WDH	DELETING OF 30" SFM SCOPE	REVISION DESCRIPTION	BY
1	7/22/26

CITY OF NEW ORLEANS, DEPARTMENT OF PUBLIC WORKS	
PROJECT NO. TM008	
7300 BLOCK OF COHN STREET	
(LOWERLINE STREET TO PINE STREET)	
UTILITY PLAN AND PROFILE

CITY OF NEW ORLEANS, DEPARTMENT OF PUBLIC WORKS
PROJECT NO. TM008
7200 BLOCK OF COHN STREET
(PINE STREET TO BROADWAY STREET)

SHEET NUMBER	
12

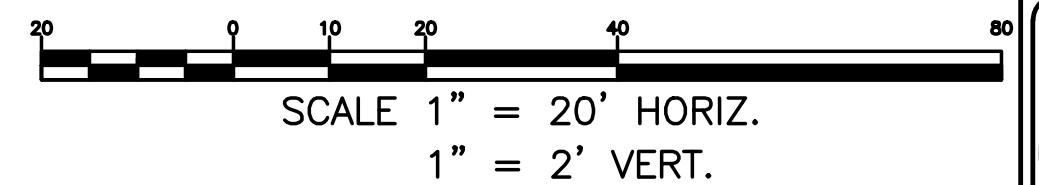
1. REMOVE + BACKFILL OF THE 30" WATER MAIN WILL BE AT NO DIRECT PAY.
2. RCP WITH LESS THAN 3' OF COVER SHALL BE CLASS IV. THE 26' OF 15" RCPA SHOWN ON SHEET 13 SHALL BE PAID BY ITEM C701(53)F(1) - RCP 15", CLASS IV, INCLUDED IN THIS ADDENDUM.

SHEET NUMBER	
13	
W/O	BY
DELETING OF 30" SFM SCOPE	REVISION DESCRIPTION
1 7/22/26	NO. DATE

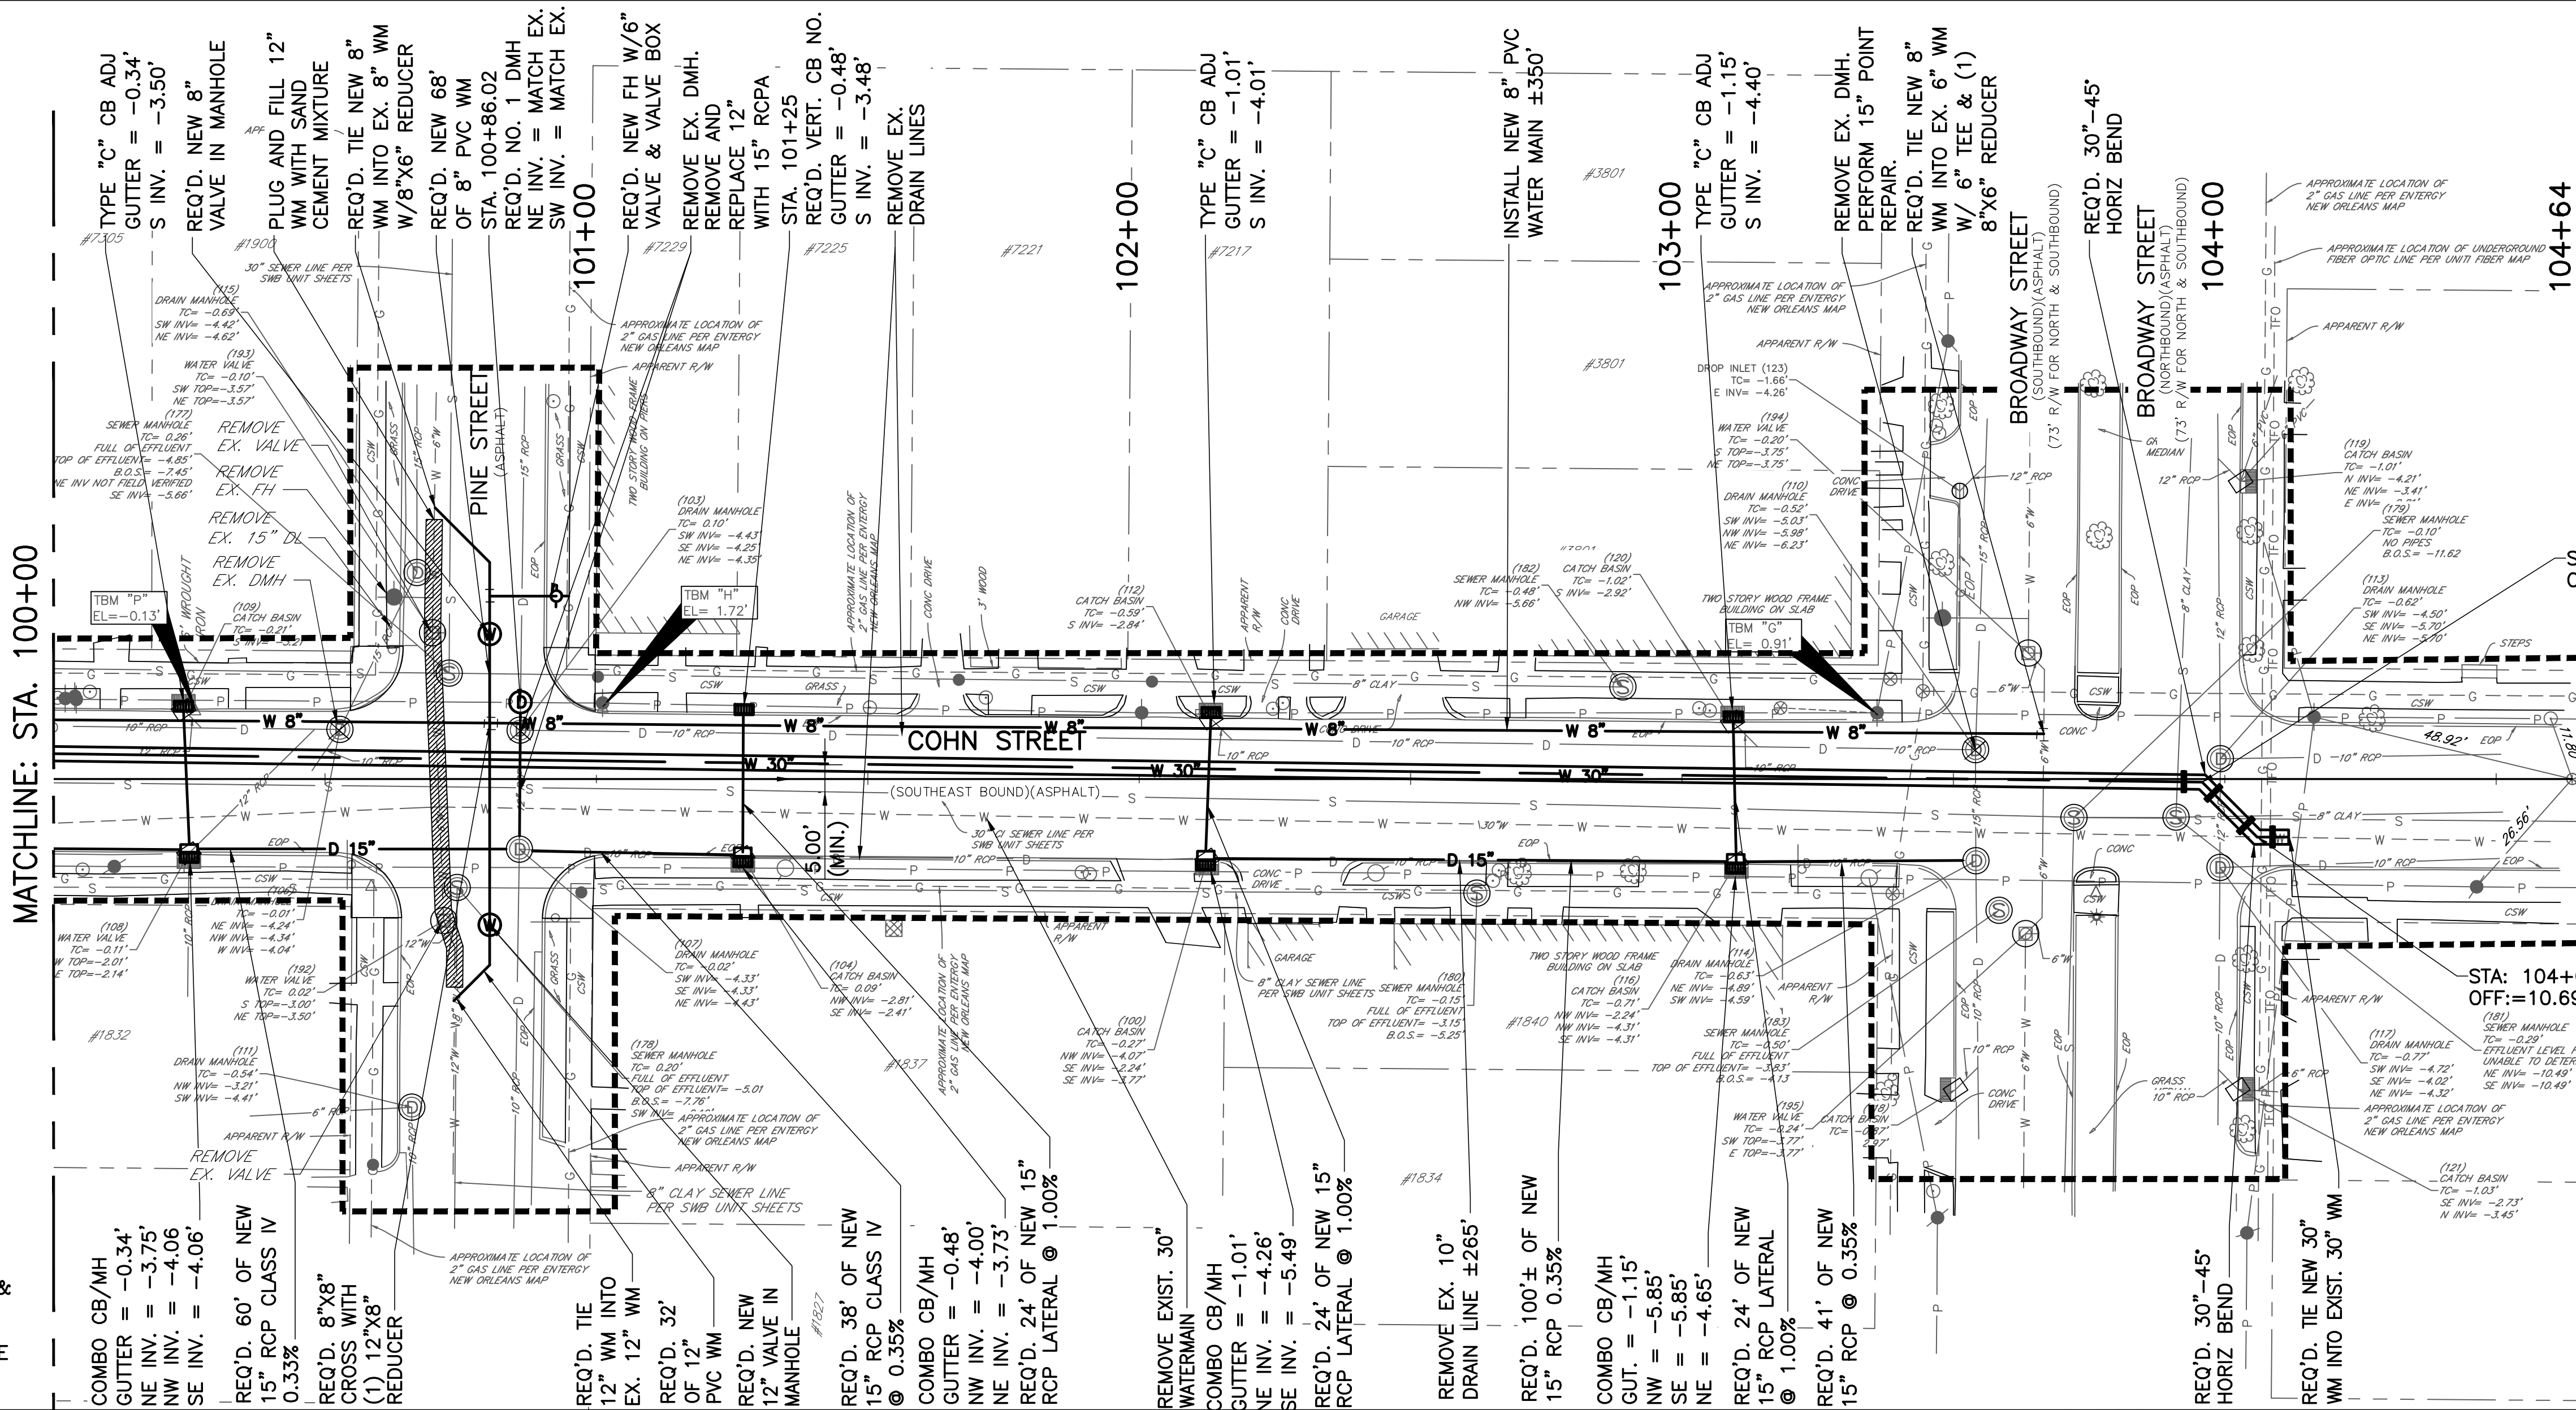
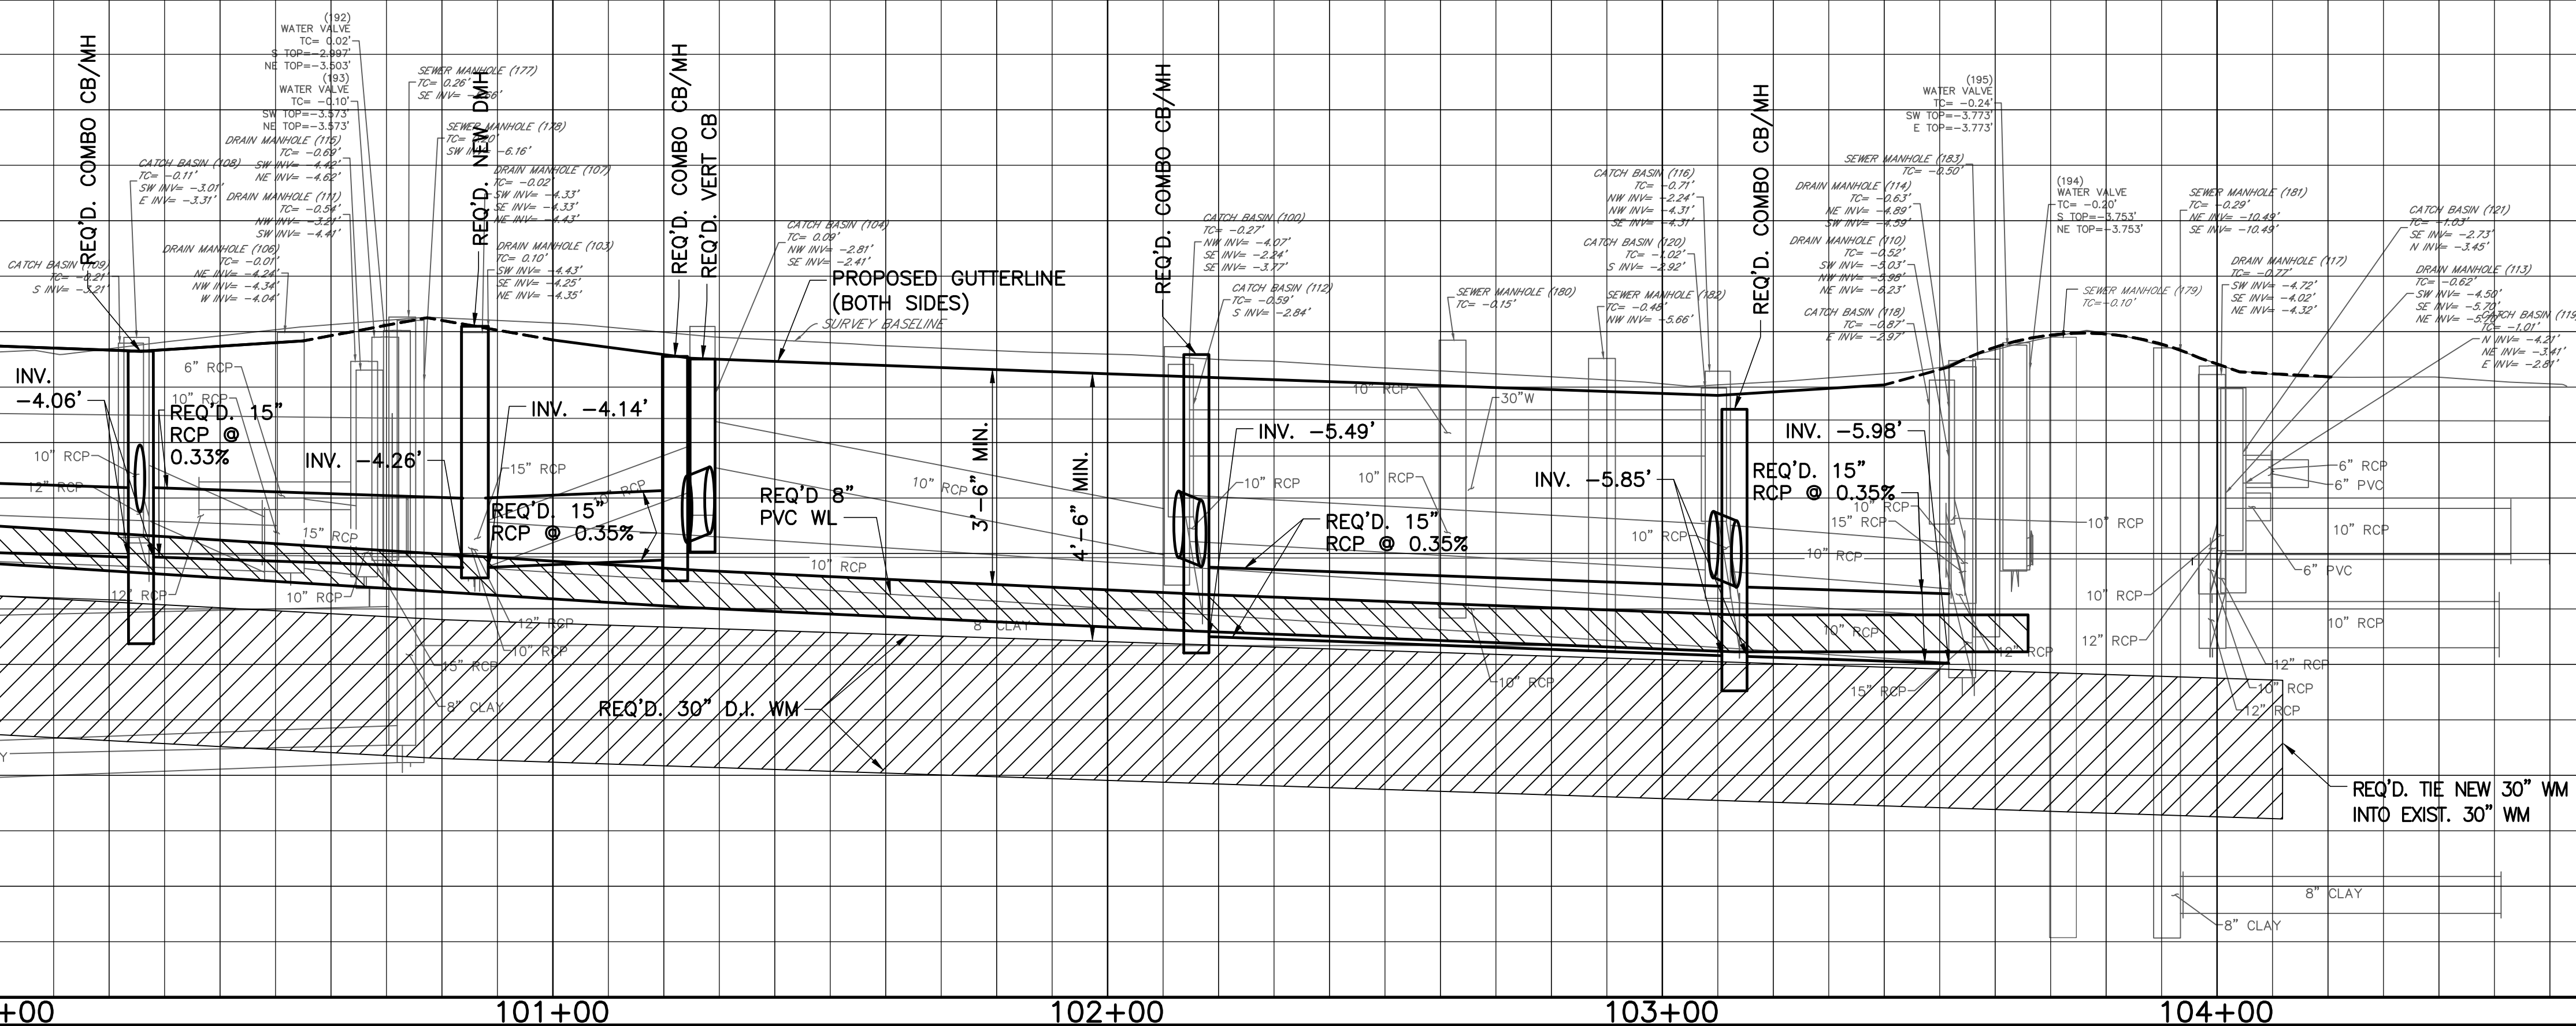
- ADDENDUM NOTES:
1. REMOVE + BACKFILL OF THE 30" WATER MAIN WILL BE AT NO DIRECT PAY.
 2. RCP WITH LESS THAN 3' OF COVER SHALL BE CLASS IV. THE 26" OF 15" RCPA SHOWN SHALL BE PAID BY ITEM C701(53)F(1) - RCP 15", CLASS IV, INCLUDED IN THIS ADDENDUM.
